Response to NERC Request for Comments on Geomagnetic Disturbance Planning Application Guide

Comments Submitted by the Foundation for Resilient Societies
August 9, 2013

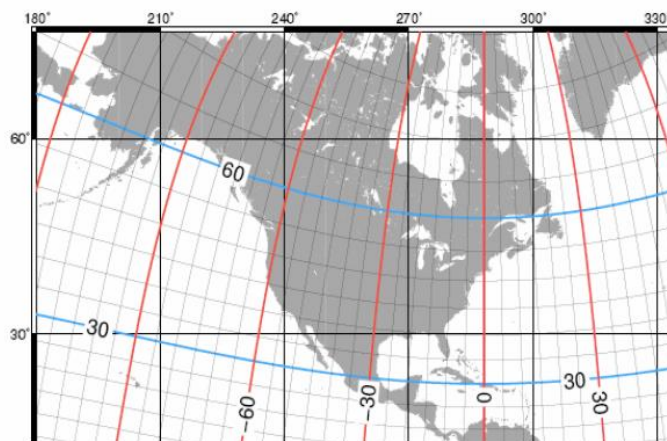
- We received several comments from the initial review
- These comments have been evaluated and implemented in the updated draft.
- A method for scaling the 1-in-100 year storm has been developed (proposed) and included in the application guide.
- Updated draft included in today's posted agenda package

Despite the above statement, "Updated draft included in today's posted agenda package," emails sent by GMD Task Force management on July 25 and July 26, 2013 did not include an updated draft of the Application Guide, nor was an updated draft posted on the GMD Task Force page of the NERC website.

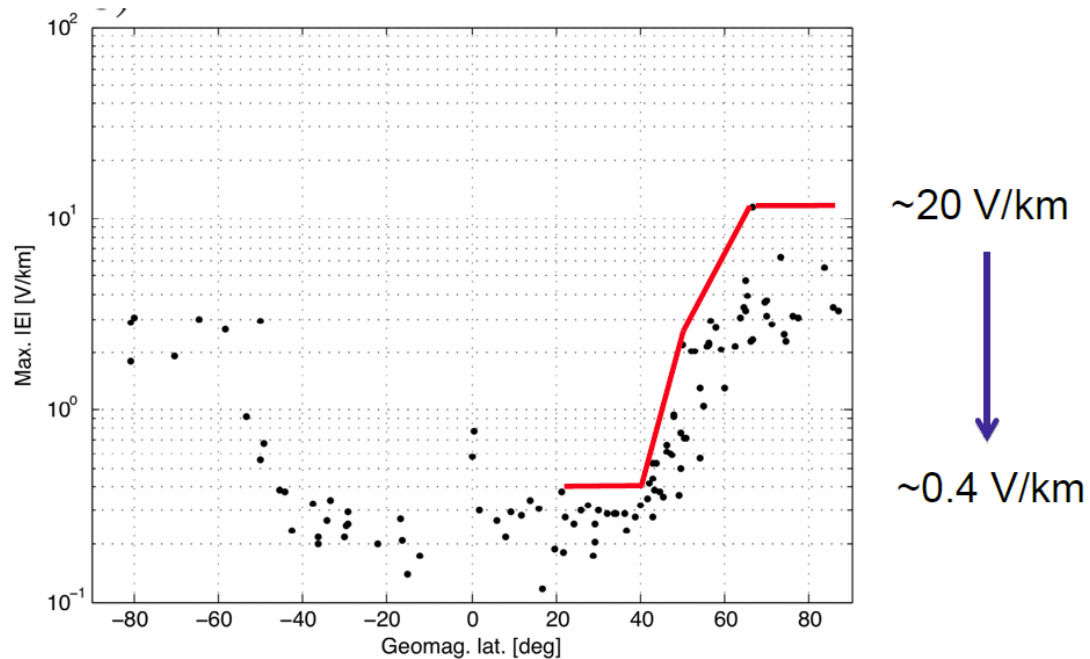
- Analysis by Pulkkinen indicates a 100-year peak geoelectric field of:
 - 5 V/km (high cond.)
 - 20 V/km (low cond.)
- Analysis also shows approximately two orders of magnitude drop from 65 deg to 40 deg of geomagnetic latitude

The above slide clearly states a maximum of 20 volts/kilometer for a peak geoelectric field in a 1-in-100 year storm.

During the presentation, Dr. Horton verbally disclosed that the above storm scaling data in the Pulkkinen analysis was taken over a thirty-year period not in the United States and Canada, but in Scandinavia. There were no severe solar storms during the thirty year observation period. NERC proposes to use this Scandinavian storm scaling data to underpin a design basis event with geoelectric field of approximately 5 volts/kilometer for latitudes within the United States.

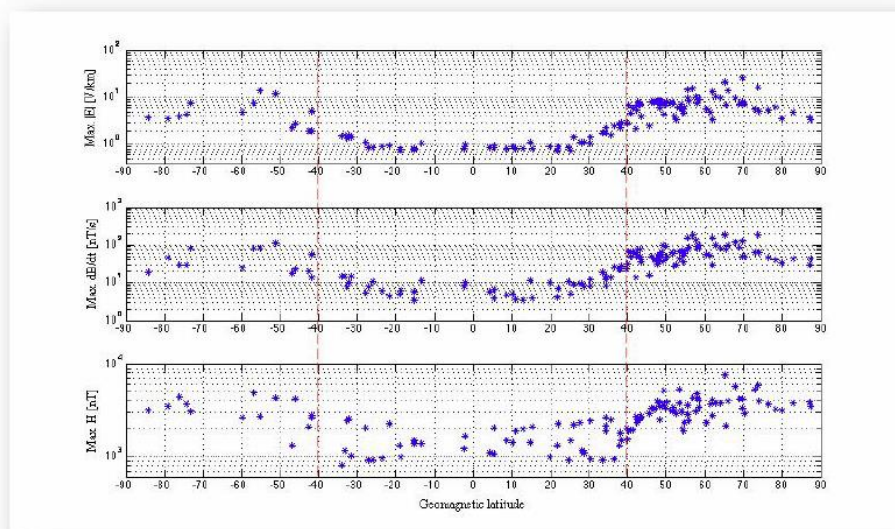
- We are getting 30-40 V/km max. fields (preliminary results)

The storm scaling data developed by Dr. Pulkkinen and presented by Dr. Horton at the July 25-26, 2013 GMD Task Force meeting in Vancouver is in marked contrast to preliminary storm scaling data presented by Dr. Pulkkinen at the February 25-27, 2013 meeting of the GMD Task Force in Atlanta, as shown in the above slide.

At the February 2013 GMD Task Force meeting, the maximum postulated geoelectric field was 30-40 volts/kilometer. At the July GMD Task Force meeting, the maximum postulated geoelectric field was 20 volts/kilometer.²

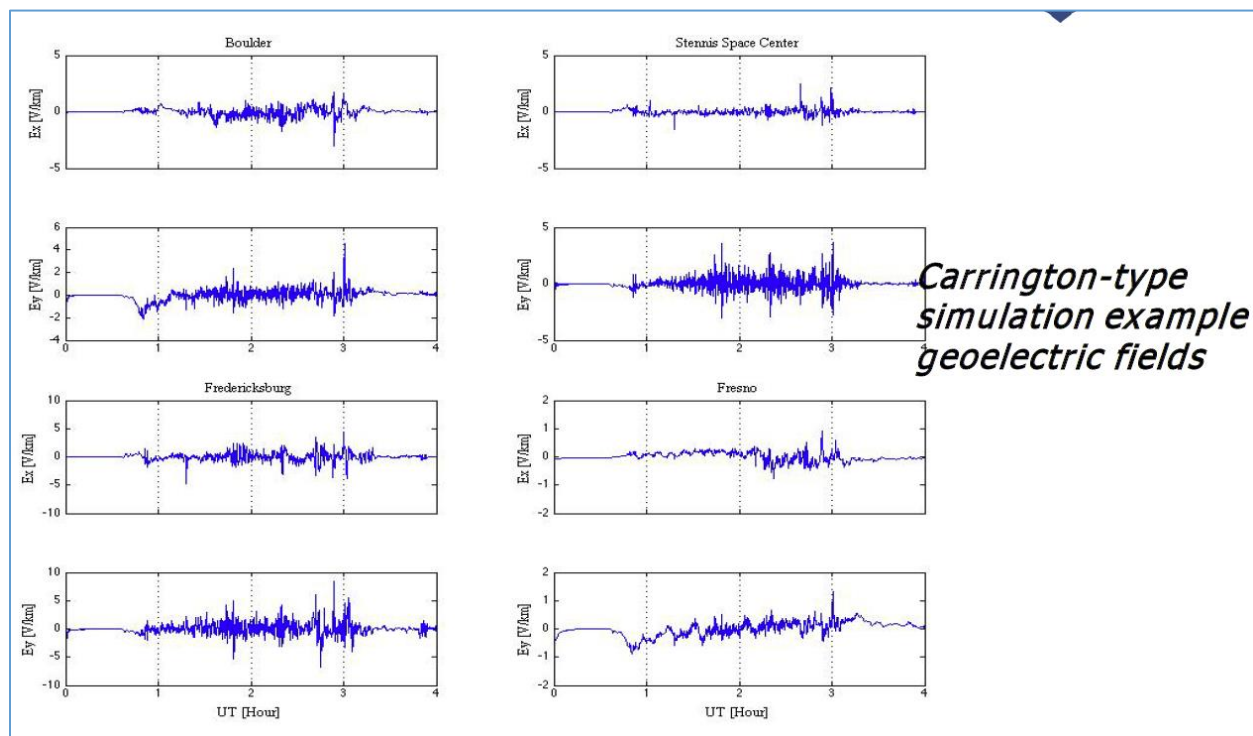
The July 2013 Horton presentation at the GMD Task Force meeting disclosed the above slide, which postulates a maximum geoelectric field of approximately 5 volts per kilometer for a “Carrington type” event at observatories within the United States. The simulation and resulting data plots were developed at University of Michigan by undisclosed researchers using an undisclosed methodology.

United States Geological Service Analysis Showing 1.7 Volts/Kilometer Geoelectric Field Shortly Before Failure of Generator Step Up Transformer at Salem, New Jersey Nuclear Plant

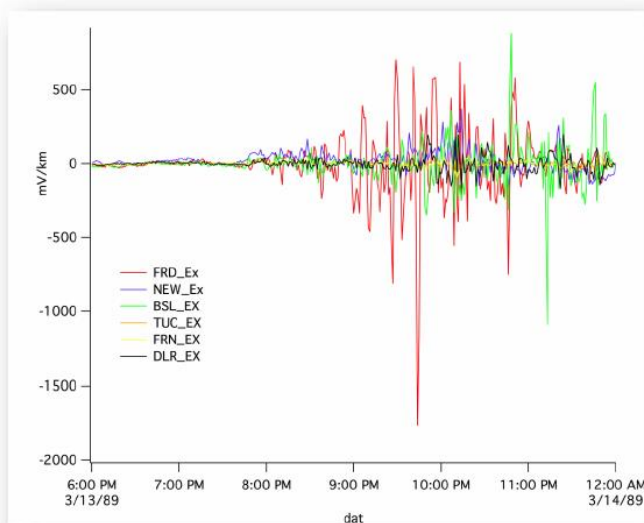
⁵ A presentation slide from the February 2013 GMD Task Force meeting showing the USGS analysis of geoelectric field from the March 1989 solar storm is included as Appendix 2.
